24590-LAW-PCN-ENV-19-008

**Hanford Facility RCRA Permit Modification Notification Form**  
**Part III, Operating Unit 10**  
**Waste Treatment and Immobilization Plant**

Modification to the Hanford Site RCRA / WTP Dangerous Waste Permit consisting of updates to Piping and Instrumentation Diagrams for the LAW Melter Feed Process System (LFP), LAW Secondary Offgas / Vessel Vent Process System (LVP), and Radioactive Liquid Waste Disposal System (RLD). Updates performed are in accordance to WAC 173-303-830, Appendix I Modification citation number: A.3., equipment replacement or upgrading with functionality equivalent components (e.g., pipes, valves, pumps, conveyors, controls).

The purpose of this Class <sup>1</sup> modification is to provide Piping and Instrumentation Diagrams (P&IDs) for the LAW Melter Feed Process System (LFP), LAW Secondary Offgas/Vessel Vent Process System (LVP), and Radioactive Liquid Waste Disposal System (RLD) for incorporation into Appendix 9.2 of the WTP RCRA permit:

REVISION HISTORY	
CONTRACT No.	DE-AC27-01RV14136
RIVER PROTECTION PROJECT WASTE TREATMENT PLANT 2435 STEVENS CENTER PLACE RICHLAND, WA 99354	
P&ID - LAW LAW MELTER FEED PROCESS SYSTEM MELTER 2 FEED VESSEL LFP-VSL-00004	
SCALE:	24590-LAW-M6-LFP-00003003
REV	1

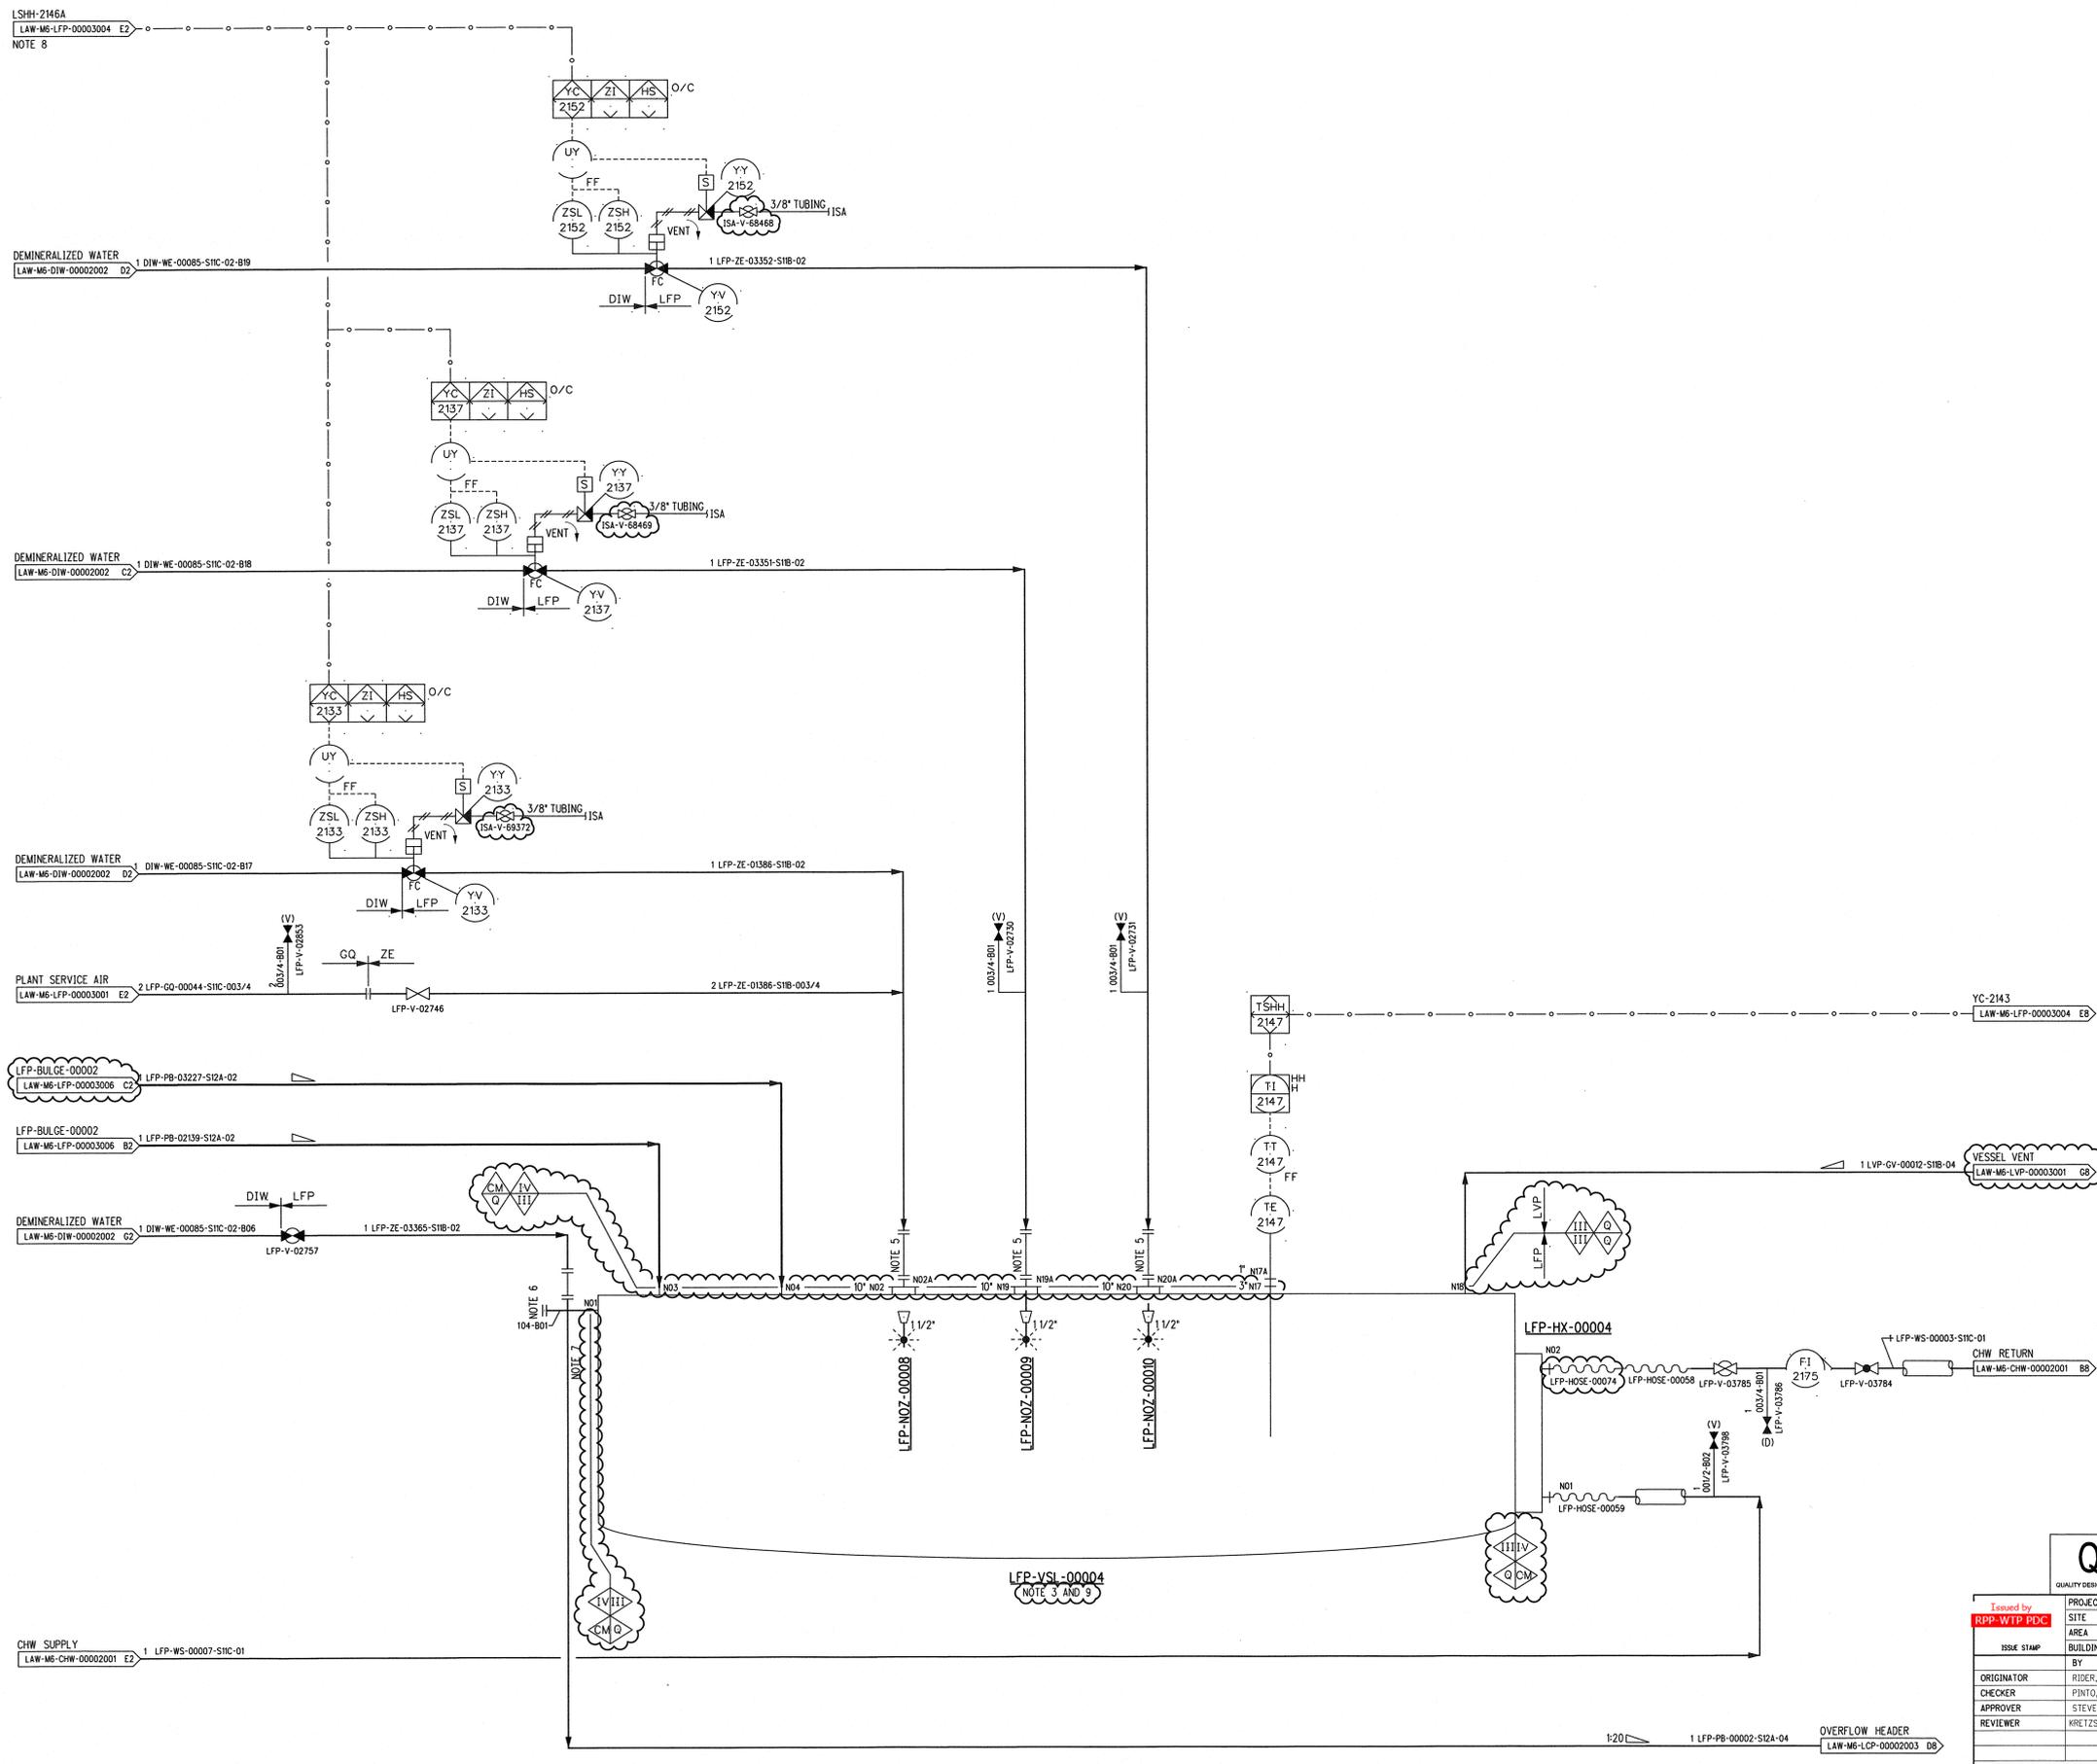
- c. Addition of Reference 1, design description of both 24590-LAW-3ZD-LFP-00001 and concentrate receipt process (LCP).
4. Significant changes incorporated into the Piping and Instrumentation Diagram (24590-LAW-M6-LFP-00003003, Rev. 1) for Melter 2 Feed Vessel LFP-VSL-00004 of the LAW Melter Feed Process System are summarized below.

- a. Addition to Note 3, quality level and seismic category of vessel, nozzles, spare nozzles and manways is specified.
  - b. Note 9 updated, unnecessary worded comparison of required seismic category of LFP-VSL-00004 to that of anchorage is removed.

- c. Addition of Note 11, Revision 1, incorporated documentation and revised references.
  - d. Addition of Reference 1, design description of both 24590-LAW-3ZD-LFP-00001 and concentrate receipt process (LCP).

- REVISION 1: INCORPORATED CHANGE DOCUMENTS 24590-LAW-M6N-LCP-00048, 24590-LAW-M6N-LFP-00044, -00063, 24590-LAW-M6N-N80T-00016 AND 24590-WTP-FC-M-17-0165. REVISED SDD REFERENCE AND ADR REVISION, ADDED CM/Q BOUNDARY AT LFP-VSL-00004 AND LFP-HX-00004 INTERFACE.
